GC0100/101/102  
Code Administrator  
Consultation Responses

Grid Code Panel

8<sup>th</sup> Feb 2018

Figure 2: Frequency Response Capability LFSM-O, LFSM-U and FSM Step Response Tests

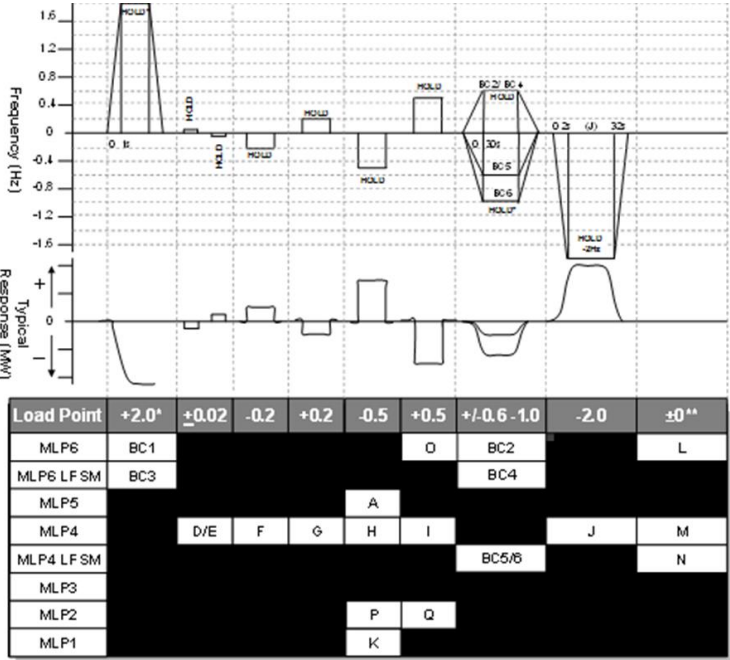
- LFSM-O only is required from type B PGMs but test regime in ECP section only allows for testing of FSM
- Grid Code text is actually compliant (see next slide)
- Interpretation of 'as much as possible' as defined in response range is contentious – and could be worded better
- In the code it is meant to indicate as much as viable rather than a cost-is-no-object solution. This is picked up by the general 'economic and efficient' licence condition.
- For both these points the Proposer's view is that the GC0100-102 solution is compliant.
- The issue may be more around existing Grid Code text.
- Note that 1<sup>st</sup> parties to use these condition will be connecting (and undergoing tests) post-May 2019.

(iii) Frequency response tests in Limited Frequency Sensitive Mode (LFSM) to demonstrate LFSM-O and LFSM-U capability as shown by ECP.A.5.8 Figure 2.

(c) governor or frequency control system tests to demonstrate that the Power Generating Module, OTSUA (if applicable) or HVDC Equipment can meet the requirements of ECC.6.3.6.2, ECC.6.3.7, where applicable ECC.A.3, and BC.3.7. In the case of a **Type B Power Generating Module only tests BC3 and BC4 in ECP.A.5.8 Figure 2** or ECP.A.6.6 Figure 2 must be completed. The results will also validate the Mandatory Service Agreement required by ECC.8.1. These tests may also be used to validate the governor model (PC.A.5.3) or frequency control system model (PC.A.5.4) as applicable. These tests may be witnessed by NGET.
